Memo

Application: Z10-0029

Address: 1096 Quesnel Road

Subject: Rezoning Application

EXISTING FLOOR PLAN

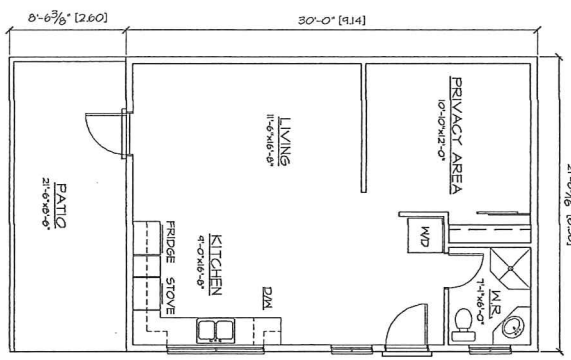
1) 1 hour fire separation is required between the suite and the storage garages as per 2006 edition of the British Columbia Building Code

2) Limited glazing amounts and glazing types (wire glass) are only allowed in the fire separation, this may affect the window and door locations.

5) A man door thru the fire separation is required to be fire rated door and have a self closing device.

6) The drawings supplied don't define the storage area to the north of the suite. Further clarification required prior to comments being provided.

No objections. Confirm there is a fire separation between the garage and the detached suite.
